Technical Decision RRJ0000-OR-053-0015

On checking the sensitive elements of the leak detection system on the RRJ-95 type aeroplane in operation

Figure 1. The location of the sensitive elements of the LDS along the air cooling pipes

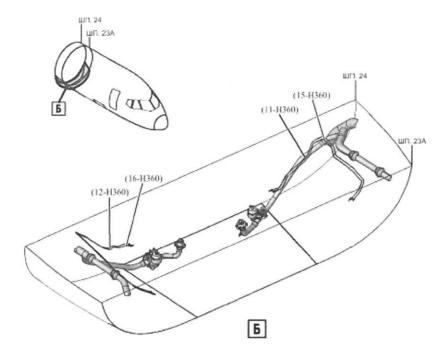
- 1. The contour along the left ACP (Air Cooling Pack) (Figure 1) sensitive elements 11-H360 and 15-H360;
- 2. The contour along the right ACP (Air Cooling Pack) (Figure 1) sensitive elements 12-H360 and 16-H360;
- 3. The contour along the mixing subsystem (Figure 2) sensitive elements 17-H360 and 19-H360.

- 1. Operators of aeroplane RRJ-95 not later than the next Maintenance Check multiple of 1500 FH after the approval date of the Technical Decision to check the prioritized sensitive elements of the Leakage Detection System (LDS) installed on the following circuit positions 11-H360, 12-H360, 15-H360, 16-H360, 17-H360, 19-H360 according to the methodology laid down in Appendix 1 to this Decision;
